Planning Commission Meeting Minutes June 19, 2017

FDM-28-2017 Final Development Plan Modification Final Development Plan modification to the Dairy Queen drive-thru at 9940 Johnstown Road within the Canini Trust Corp subarea 8a (PID: 222-000347) Applicant: Ice Queens of Smiths Mill LLC

Final Development Plan for a 240 lot age-restricted residential housing development on 89.6 +/- acres for the subdivision known as Nottingham Trace located west of State Route 605, south of Walnut Street, and east of the Upper Albany subdivision (PID: 220-004443, 222-004445, 222-004444 and 220-004445). Applicant: Pulte Homes c/o Aaron L Underhill, Esq.

Planning Commission Staff Report June 19, 2017 Meeting

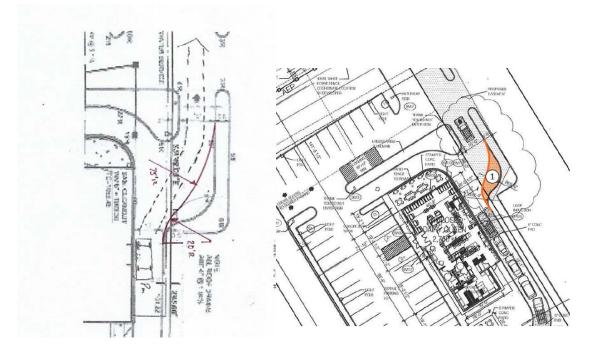
The City Engineer and City's Landscape Architect have reviewed the referenced plan in accordance with the engineering related requirements of Code Section 1159.07 and provided the following comment(s):

The City's Engineer agrees with this concept and designed the drawing on the left to assure that the suggested path will provide adequate maneuverability for cars.

Staff recommends approval should the Planning Commission find that the application has sufficient basis for approval. Staff is supportive of the proposed modification but recommends the Planning Commission evaluate the internal turning radius of the exit drive. It appears extra green space can be provided by reducing the turning width of the proposed drive connection.

- 1. A copy of the recorded easement is submitted between the property owner and the applicant.
- 2. The final exit design be redesigned based on the City's Traffic Engineer so there is less pavement added.
